# Service Bulletin

94

42" & 48" ROTARY MOWERS  
Models RL426, RL486, 5-1421, 5-1481

## Mower Installation & Removal

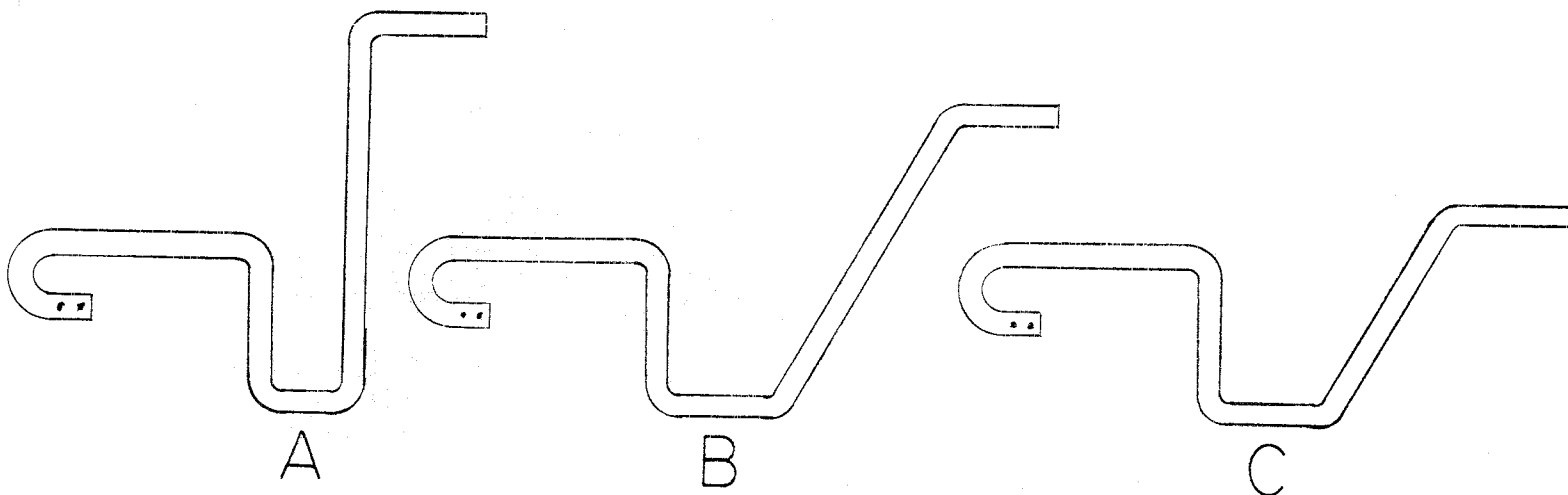
Since the introduction of the RL series mowers, three (3) different height control rods have been used as shown in the accompanying sketch.

The early rod (type A) may interfere with the tractor foot rest on late model (Charger & Raider) tractors. The type A rod (6721) may be modified to the type B configuration which will provide additional clearance. If desired, for more convenience, the latest type C rod #7677 may be installed.
